PCN – Process Change Notification

Change:	AP.25F.41.3050D
Date:	201710/12
Author	Cedric Chang

Model#	Part Number	Changes
AP.25F - 2 Stage 30dB-3050mm RG-174 SMA(F)- SAW Filter	AP.25F.41.3050D	Amend the current value.

Illustration of Change

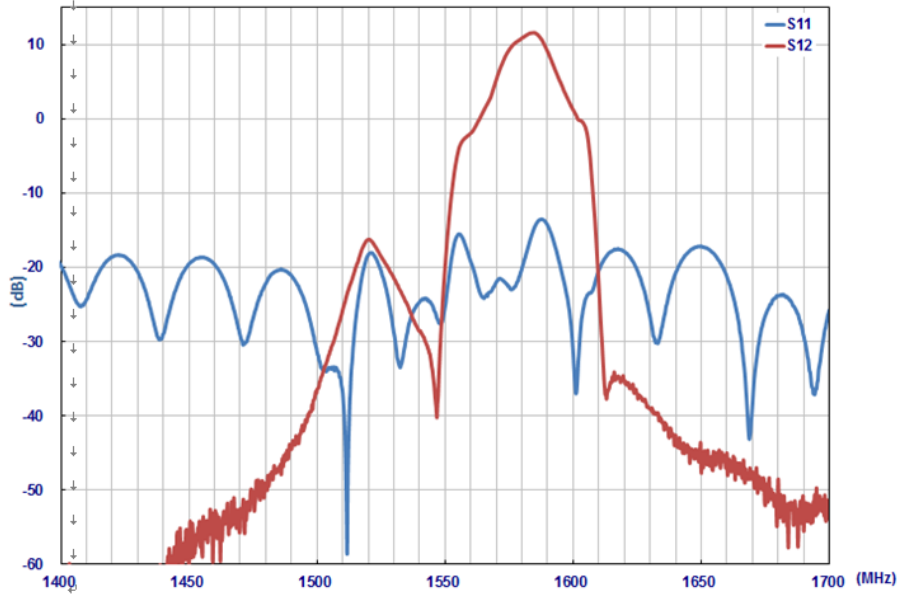
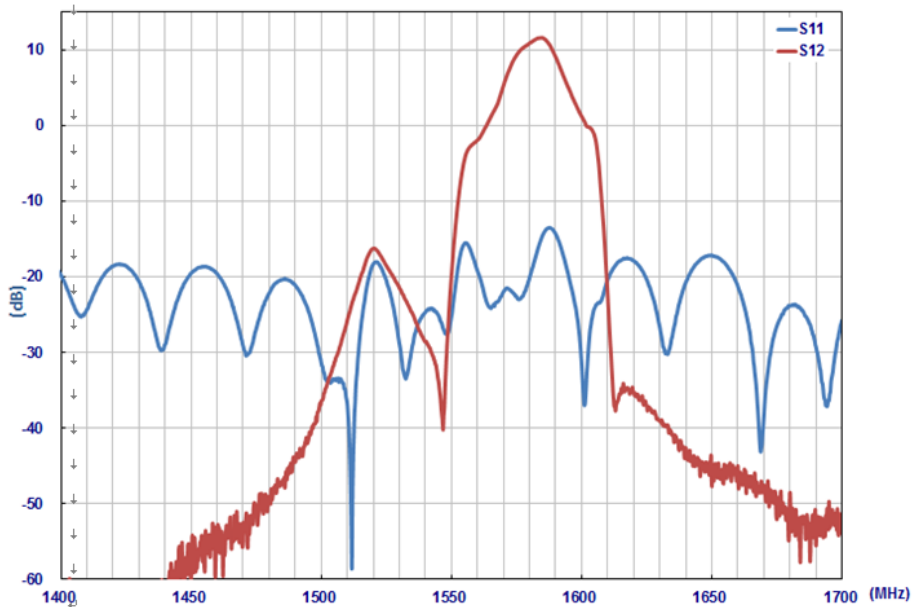
- Amend the inspection power consumption current value to meet the real sample inspection value on production line.

S11(dB)	S12(dB)	Power Consumption(mA)
Limit value	$S11 < -10$	$-1 < S12 < 13$	14 ~ 16

S11(dB)	S12(dB)	Power Consumption(mA)
Limit value	$S11 < -10$	$-1 < S12 < 13$	8 ~ 15
